Impact Assessment Agency of Canada

DRAFT ANALYSIS OF PRODIGY GOLD INCORPORATED'S PROPOSED
CHANGES TO THE MAGINO GOLD PROJECT

JUNE 2023

Figure 1 – Site layout with the proposed project changes

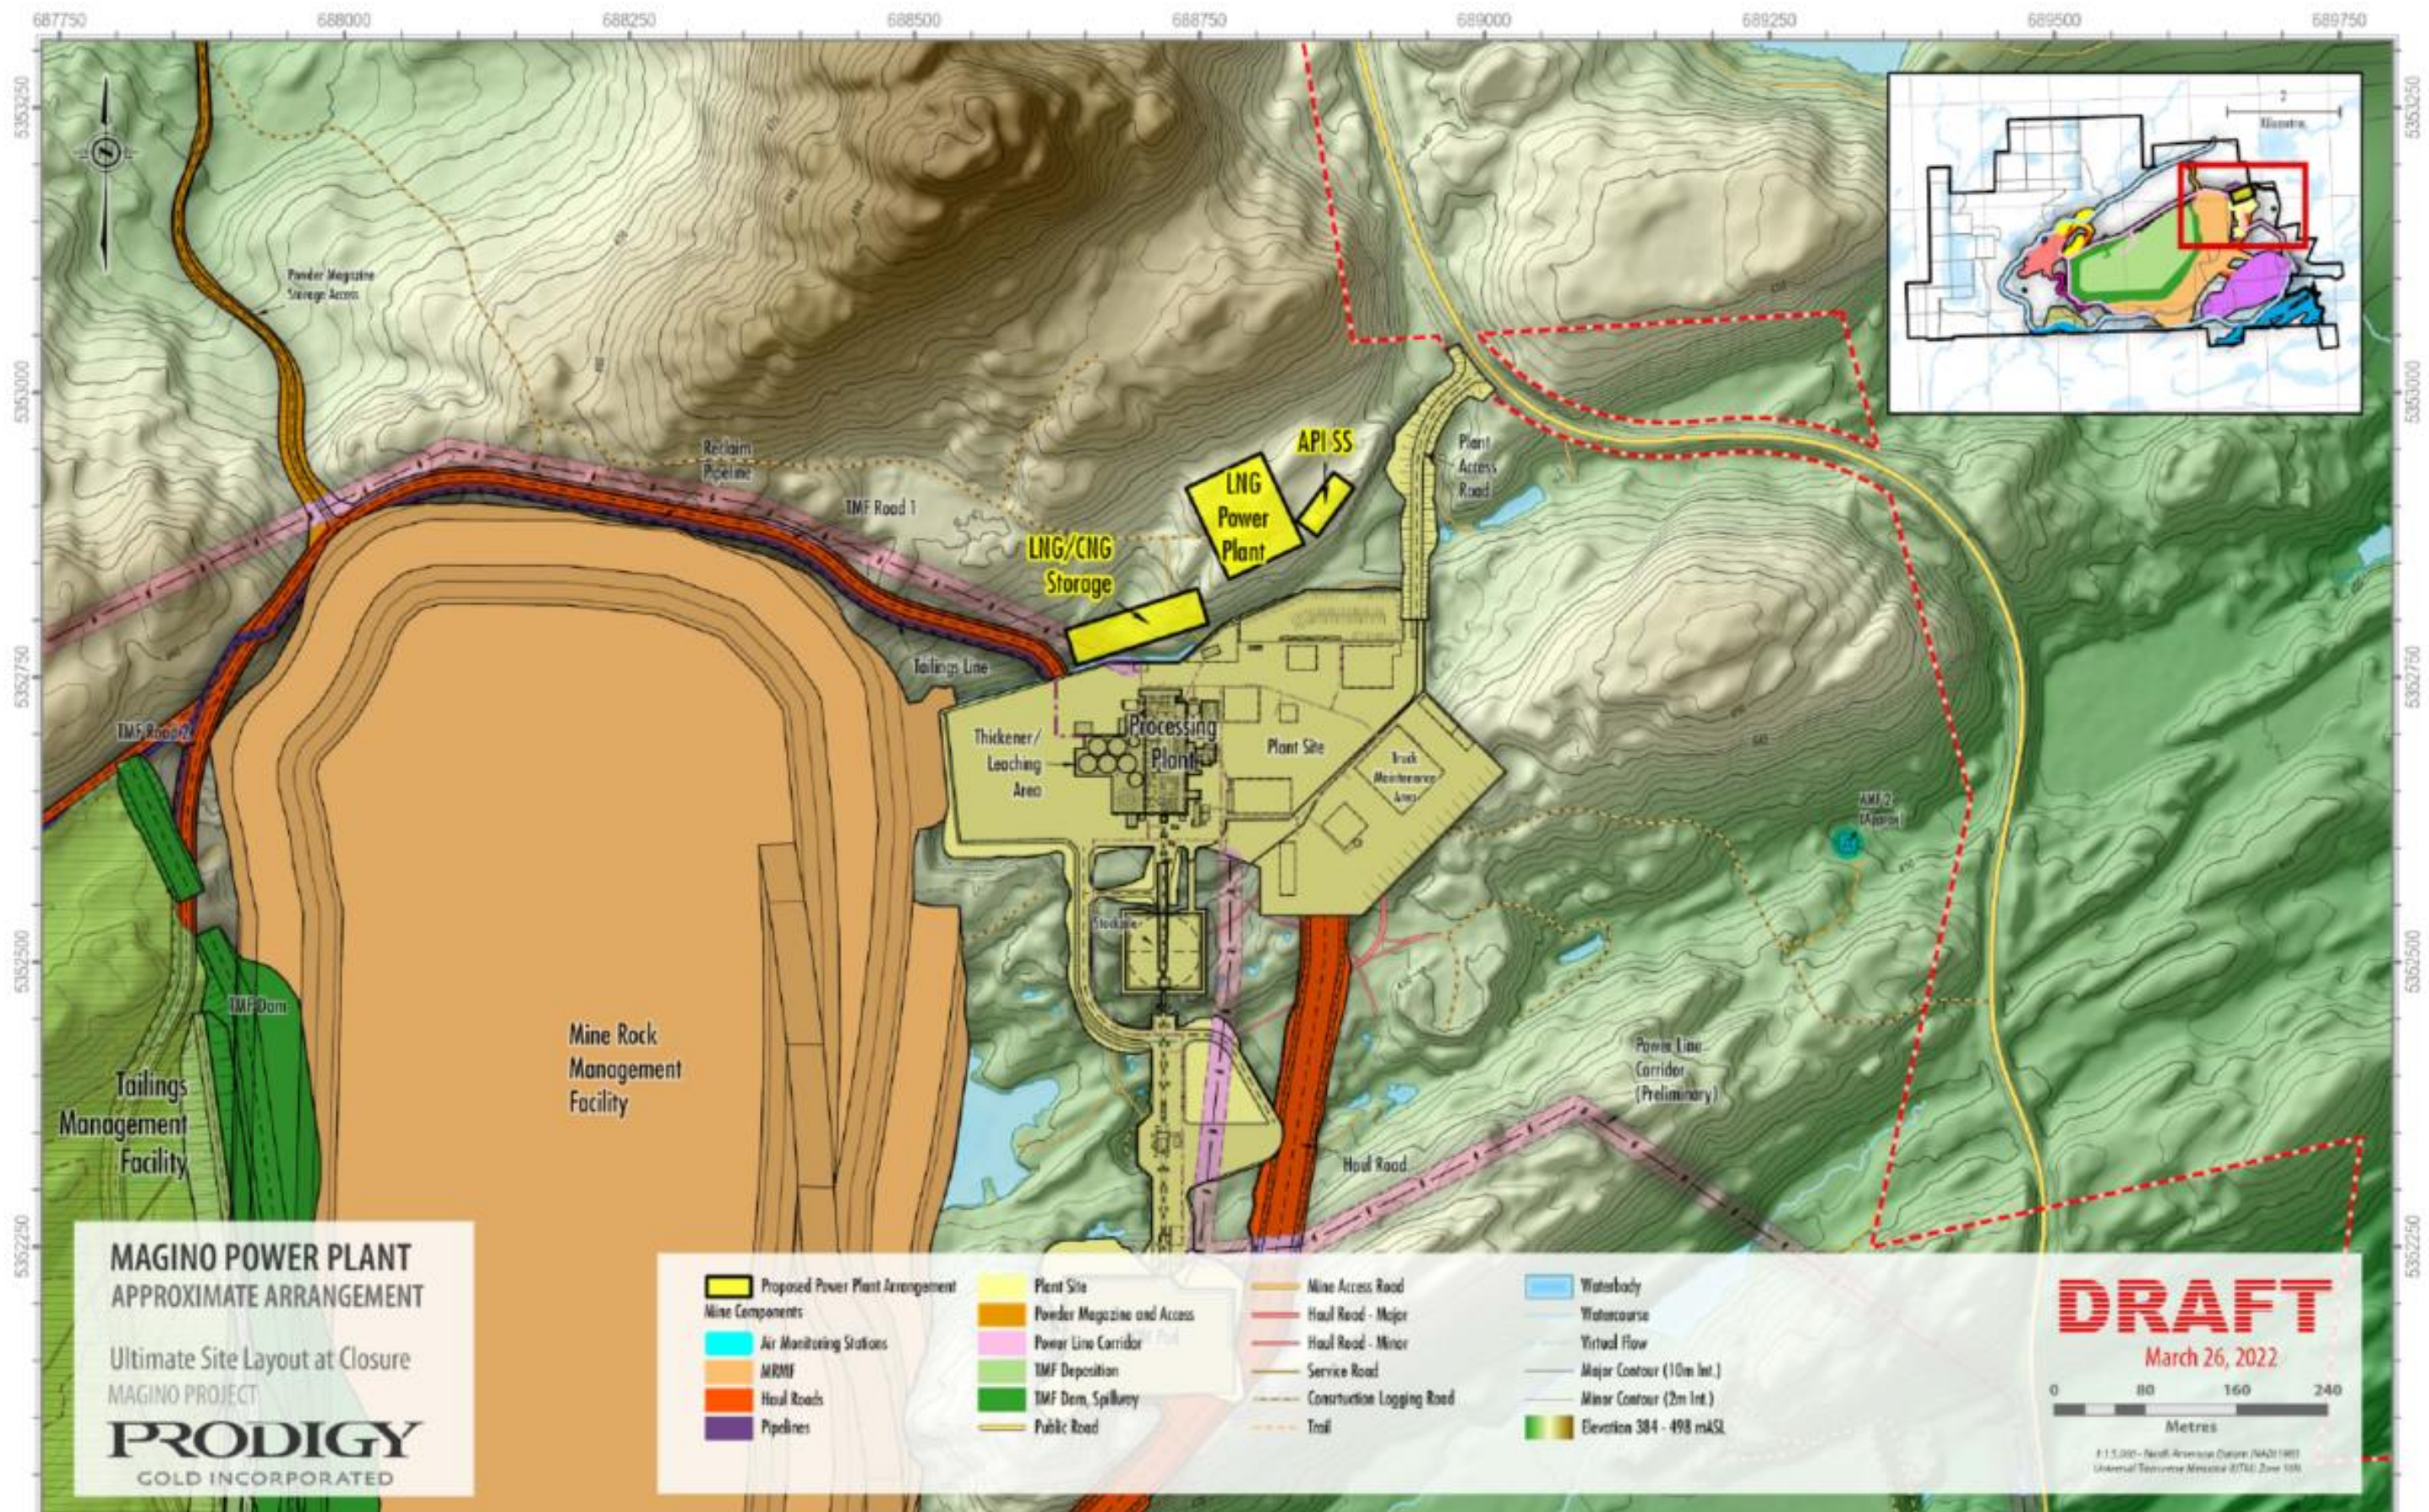
The proposed project changes include the construction and operation of a 22-megawatt on-site liquefied natural gas-fired electrical power generation facility (LNG power plant) and associated infrastructure such as its storage facility, electrical distribution lines and substation, and power generation equipment. It also includes rerouting and upgrading an existing 44-kilovolt distribution line (the distribution line) from within the area of the open pit. These proposed project changes will be within the overall footprint of the Project (Figure 1). The LNG power plant and its associated infrastructure will be built and commence operations over a period of approximately 12 months.
